Access Compliance Report

Public Rights-of-Way (Curb Ramps)

Intersection ID: 7057	Main Street: KENDRICK_AV	Cross Street: STATESVILLE_RD	Location: NE
ADA ID: 569D1D3247C0	Ramp Type: Directional1	Initial Pass/Fail: Fail	Overall Compliance: No
Severity Score: 1.25			
Codes/Mitigation Info/Possible Solution		Field Measurements/Component Compliance

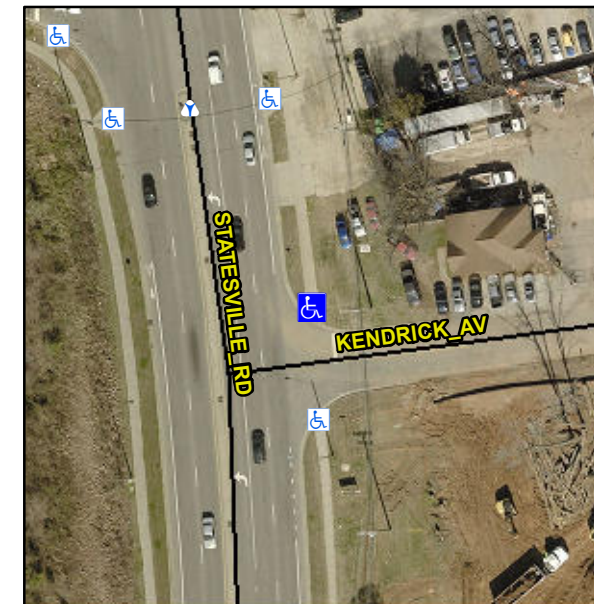
R304.5.3

Compliance	Description	Data	Compliance	Description	Data
N/A	Ramp Length (in)	138.5	N/A	Grade Break?	N/A
Yes	Ramp Width (in)	77.5	N/A	Grade Break Slope (%)	0.0
Yes	Ramp Slope (%)	6.4	N/A	Grade Break XSlope (%)	0.0
No	Ramp XSlope (%)	2.7			
N/A	Flare Type LT	N/A	N/A	Flare Type RT	N/A
N/A	Flare Slope LT (%)	N/A	N/A	Flare Slope RT (%)	0.0
N/A	Flare Traversable LT?	N/A	N/A	Flare Traversable RT?	N/A
N/A	Landing Length (in)	0.0	N/A	DWS Provided?	N/A
N/A	Landing Width (in)	0.0	N/A	DWS Contrast?	N/A
N/A	Landing Slope (%)	0.0	N/A	DWS Length (in)	N/A
N/A	Landing X Slope (%)	0.0	N/A	DWS Full Width?	N/A
N/A	Landing Curb? (Y/N)	N/A	N/A	DWS Offset LT (in)	N/A
N/A	Shared Landing?	N/A	N/A	DWS Offset RT (in)	N/A
N/A	Gutter Ponding?	0.0	N/A	Gutter Slope (%)	N/A
N/A	Gutter Lip Ht (in)	0.0	N/A	Gutter X Slope (%)	N/A
N/A	Painted X Walk1?	No		Road Slope (%)	0.8
	X Walk 1 Direction	To S		Road X Slope (%)	1.5
	X Walk 1 Width (in)	N/A		Clear Space?	N/A

Remove & Replace Entire Ramp.
